CITY OF MIAMI

ADDENDUM No. 6

INVITATION TO BID No. 08-09-054

Robert King High Park Community Center, B-35868

WINDOW TYPES
 SCALE: 1/4" = 1'-0"

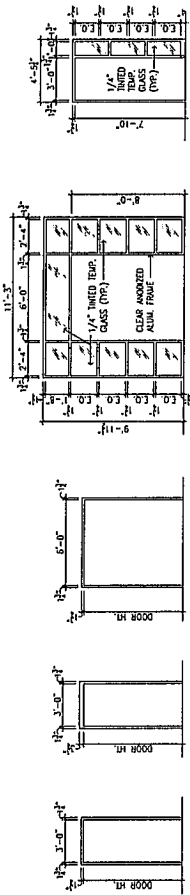
- Q1. The dimensions of the windows in the window schedule on sheet A602 do not match the floor plans or elevations. Please advise.
- A1. Window Schedule has been revised and Building Section 4/A301 has been revised to match window types and floor plan – refer to revised sheets A301 and A602.
